Subject: FCC Class II Permission Change Request for FCC ID: 2ADTD-KB6003

This is to request a Class II Permission Change Request for FCC ID: **2ADTD-KB6003** , originally granted on 2017-04-24

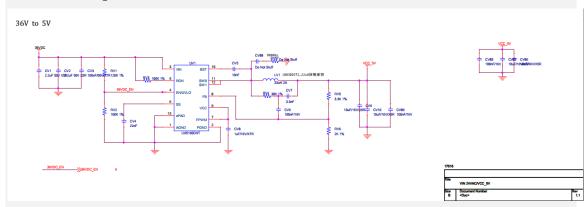
The Major change filed under this application is

Product specification change:

Before the change: AC 16V-24V, 0.37A MAX, 6W MAX

After the change: AC 16V-24V,0.37A MAX,6W MAX or DC 12V,0.5A MAX

power supply circuit change:

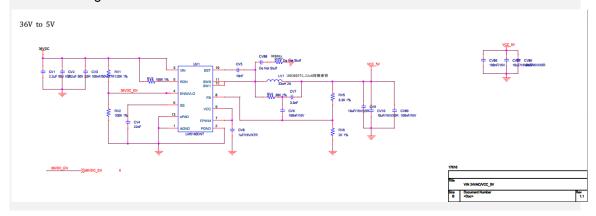
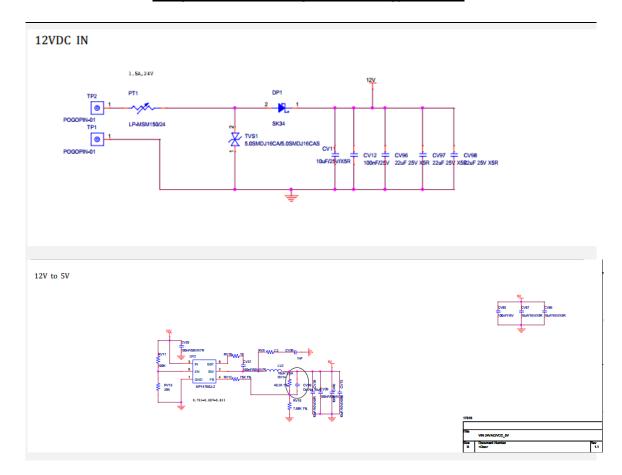
Before the change:

After the change:
